TRANSMITTAL OF VARIANCE TO REVISION 2 OF THE OPERATIONS AND MAINTENANCE MASTER PLAN (OMMP) FOR OPERATIONAL PERIOD 5

VARIANCE / FIELD CHANGE NOTICE

DOCUMENT TITLE: Operations and Maintenance Master Plan for Aquifer Restoration and Wastewater Treatment

ATTACHMENT 1Section 3.3.5: Silos Wastewater Treatment (SWT)

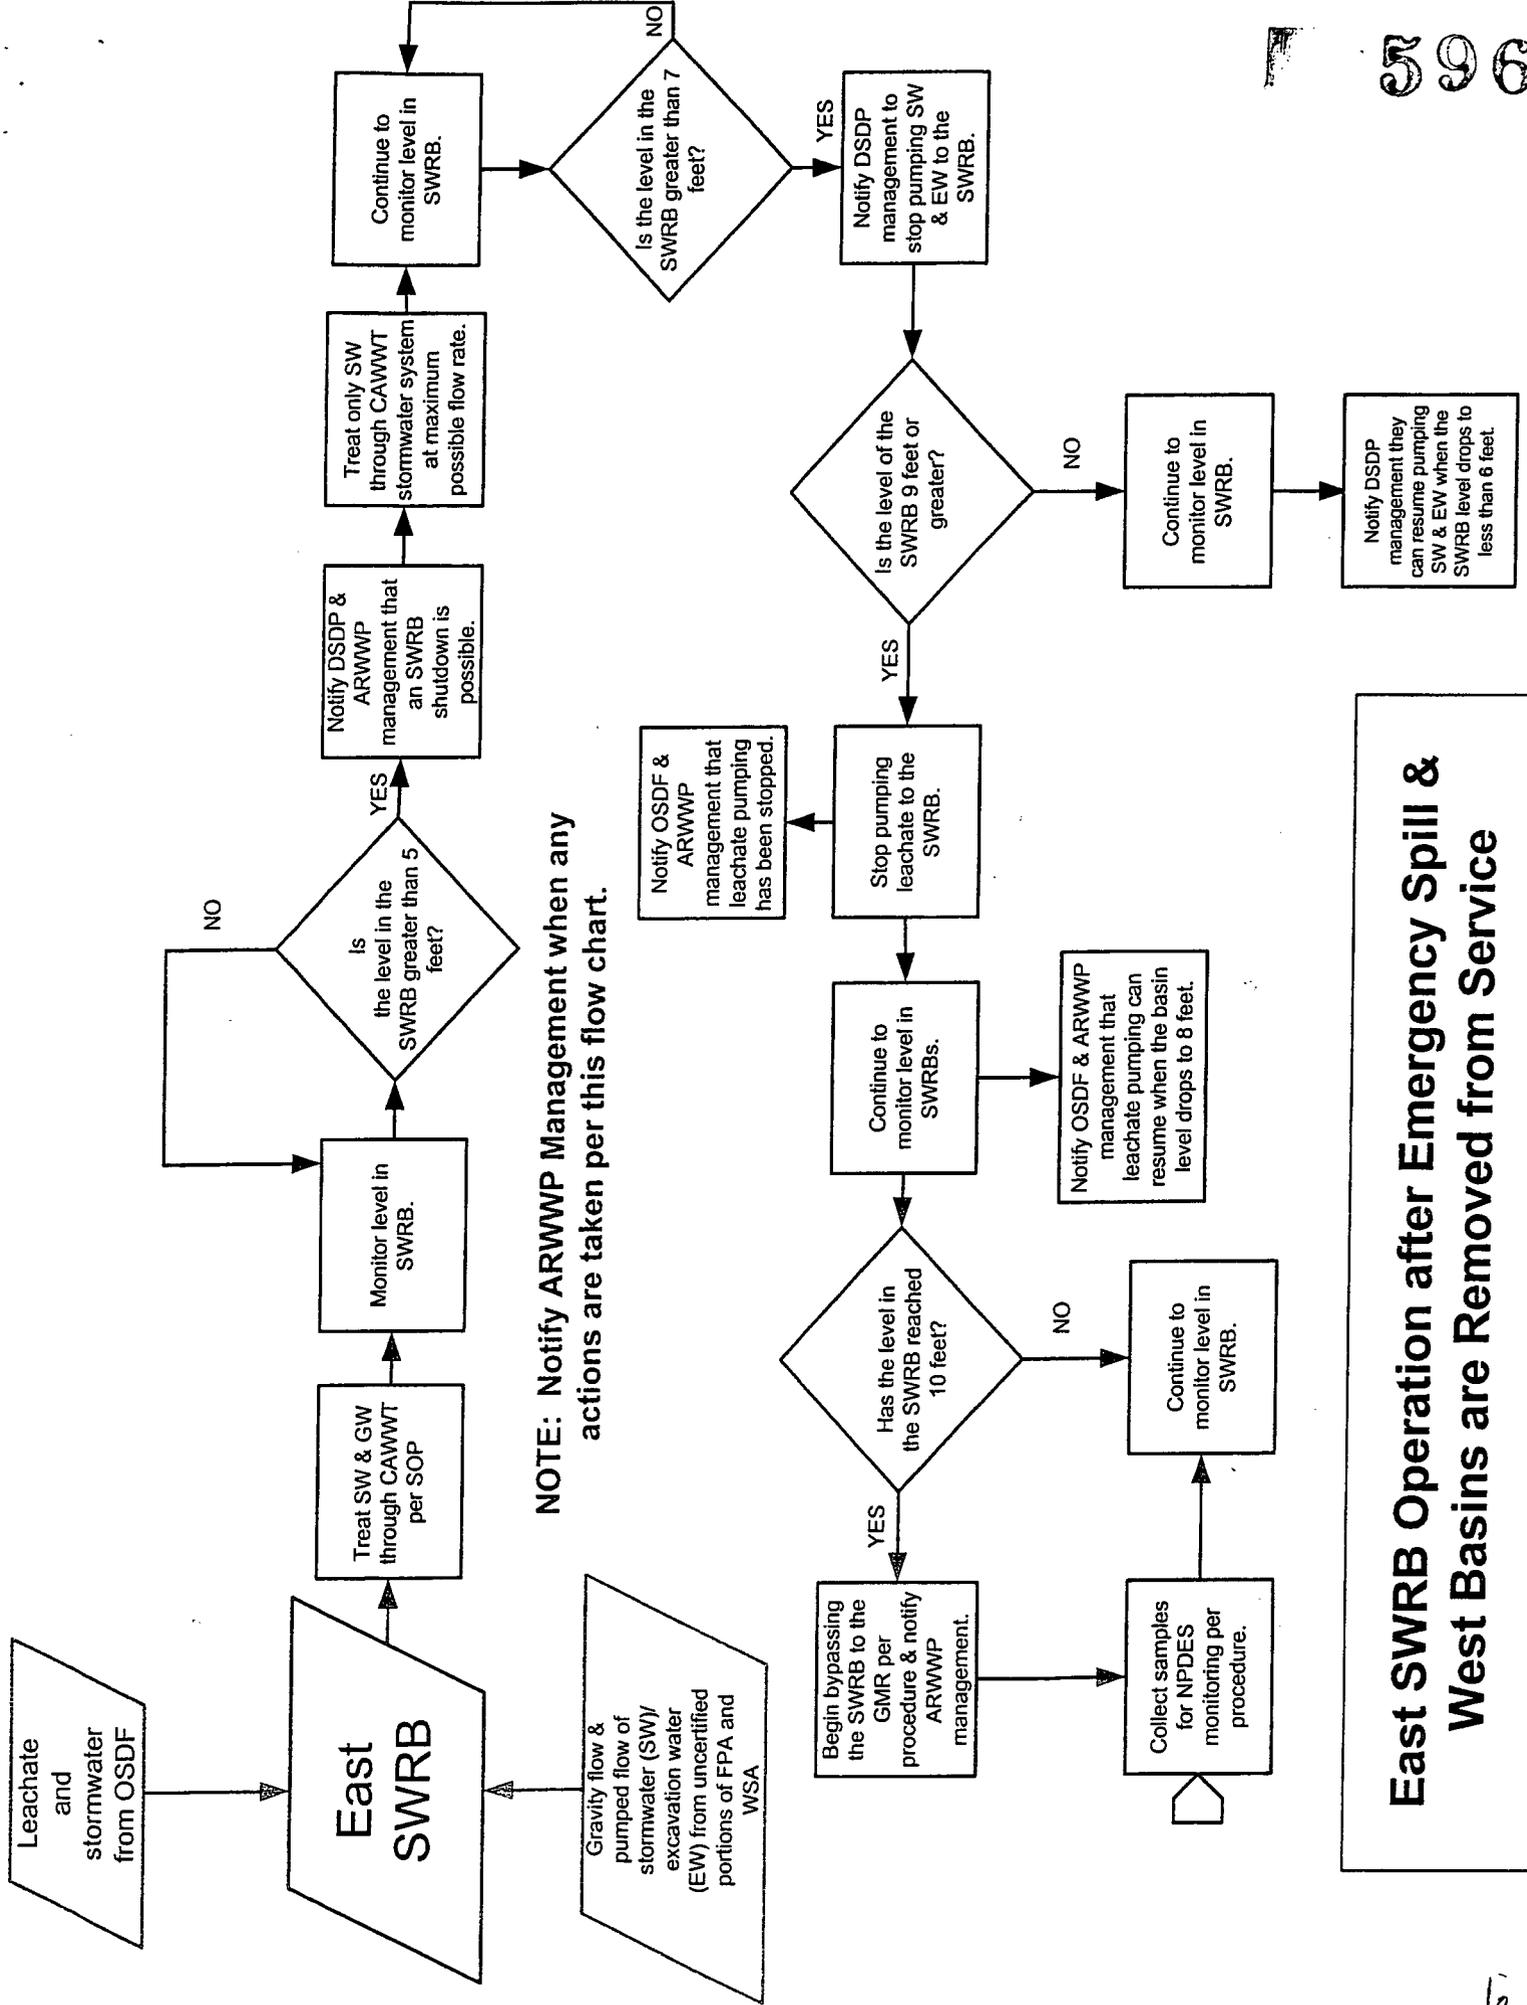
Add Silos 1 & 2 Wastewater Treatment facility operational description (Attachment 1) as Section 3.3.5.

After the material from Silos 1 & 2 that is currently stored in the TTA tanks has been treated through the Waste Treatment and Packaging (WT&P) system, some amount of water will be used to flush all equipment in the WT&P facility in preparation for demolition. This water will be treated through the WT&P clarifier for gross removal of lead, radium and uranium. Lime will be added to the clarifier along with other coagulants and/or flocculants to facilitate precipitation of lead, radium and uranium. The clarifier solids will be processed through the feed tanks and mixers in the same manner as the silos solids. The supernatant will be filtered through cartridge filters in the WT&P facility and then transported by tanker to the new Silos Wastewater Treatment (SWT) process.

The SWT will be located in the existing SPIT facility and will reuse equipment from the SPIT and IAWWT processes. The SWT treatment process will consist of an influent feed tank, pumps, bag and cartridge filters for solids removal, activated carbon for lead removal and ion exchange for radium removal. The effluent from the SWT will be discharged to the existing FCP effluent line in the SWRB Valve House and through the Parshall Flume monitoring point to the Great Miami River.

The ion exchange resin to be used is Dowex RSC manufactured by the Dow Chemical Company. RSC is a radium selective complexer resin designed for radium removal from groundwater.

The design flow rate through the SWT is 50 gpm.

East SWRB Operation after Emergency Spill & West Basins are Removed from Service

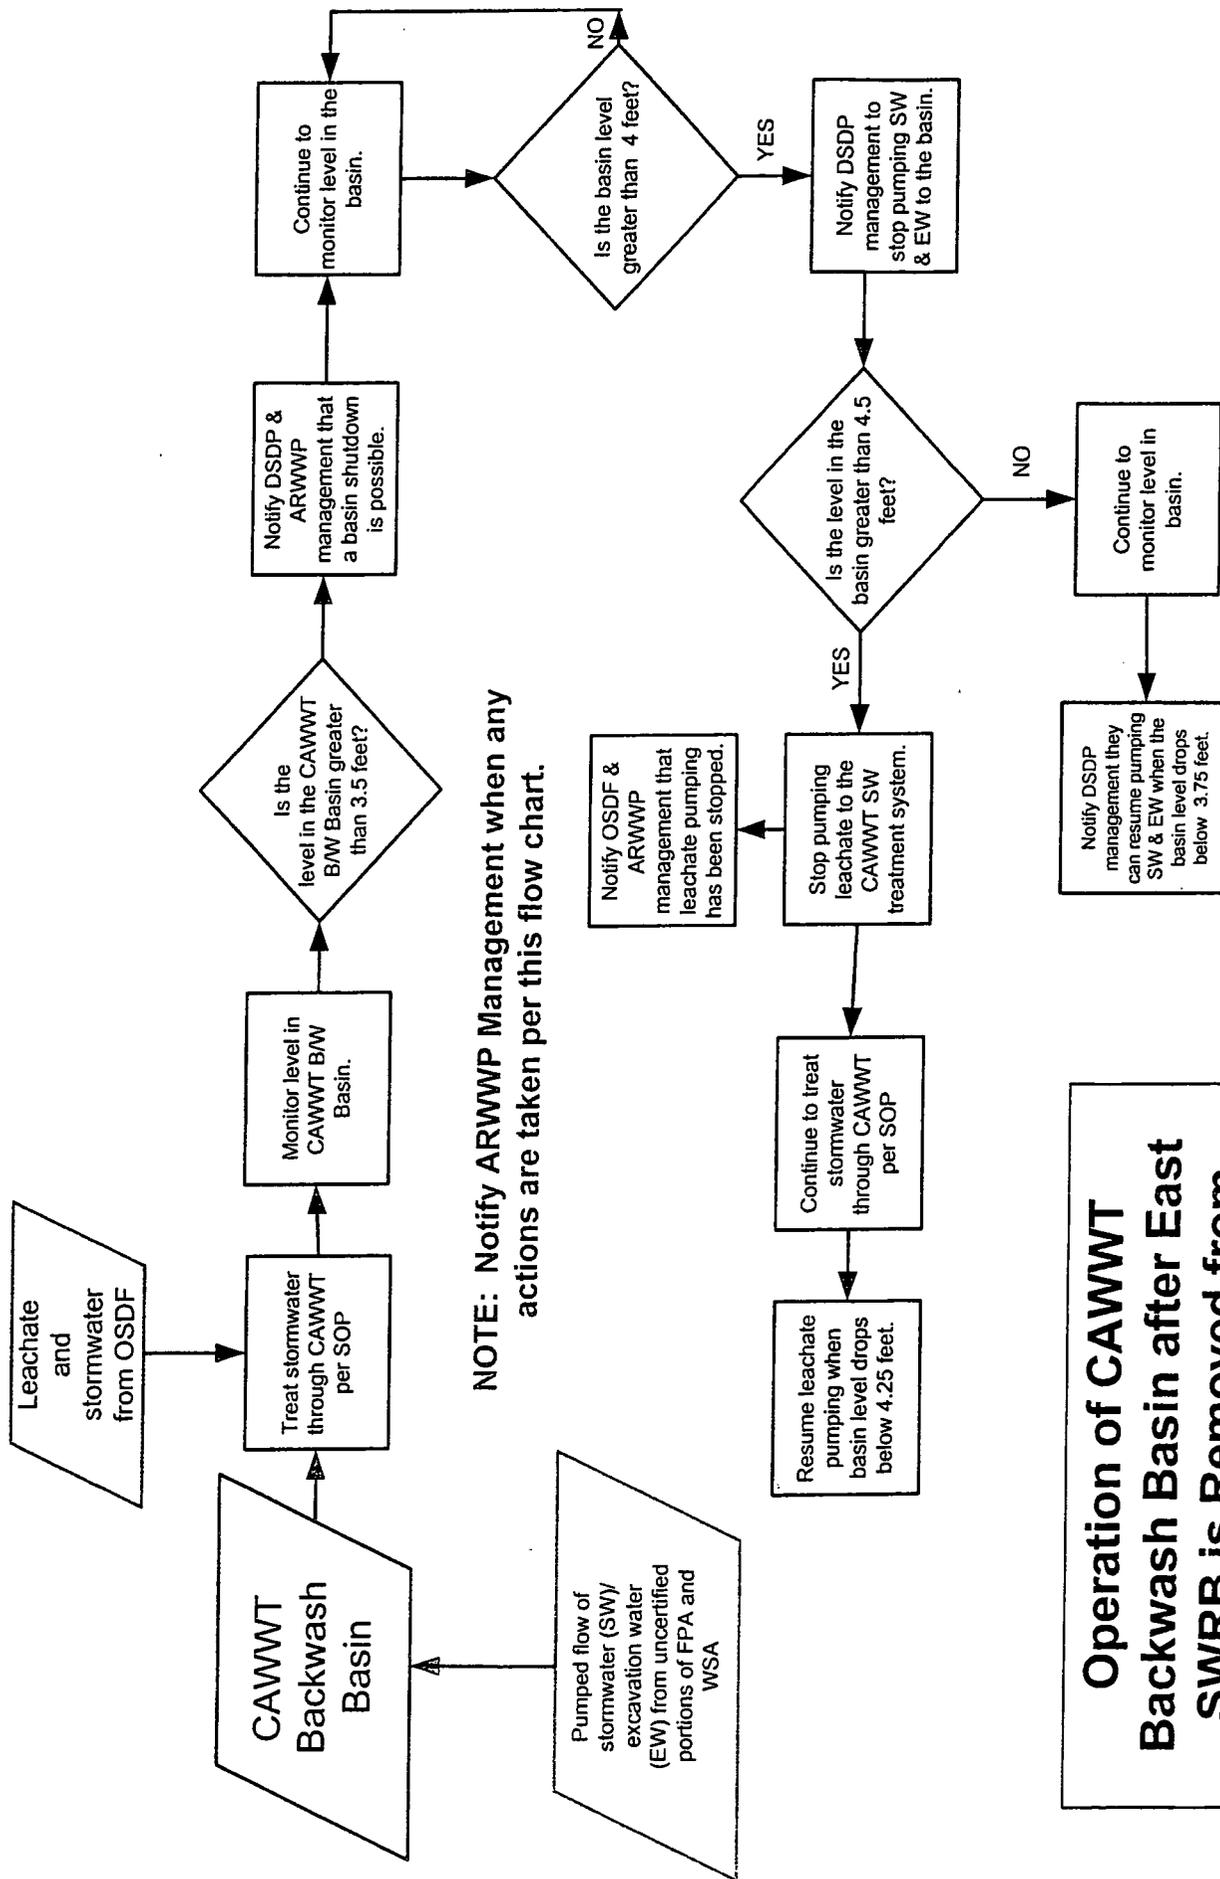
Add East SWRB Operational Instructions (Attachment 2) to Section 5.4.3 Operational Period 4.

During the period of time while the East SWRB is in service receiving Leachate from the OSDF and stormwater/excavation water from the uncertified portions of FPA and WSA, the following operational mode will be used:

1. When the level in the East SWRB reaches 5 feet, organizations that are pumping into the East SWRB and ARWWP Management will be notified that a shutdown is possible. The entire capacity of the CAWWT stormwater train will be dedicated to treating water from the East SWRB.

2. When the level reaches 7 feet, DS&DP will be notified to stop pumping into East SWRB and ARWWP Management will be notified.
3. When the level reaches 9 feet, leachate pumping will be stopped and DS&DP and ARWWP Management will be notified.

4. When the level reaches 10 feet, water from the East SWRB will be pumped directly to the Great Miami River bypassing treatment. The CAWWT stormwater system will continue to treat as much stormwater as possible while the excess is being bypassed. Bypassed water will be sampled per the NPDES permit requirements. ARWWP Management will be notified.

5. Bypassing will be stopped when the level drops to 9 feet and ARWWP Management will be notified.
6. Leachate pumping will be resumed when the level drops to 8.5 feet.

7. DS&DP pumping will be resumed when the level drops to less than 6 feet.
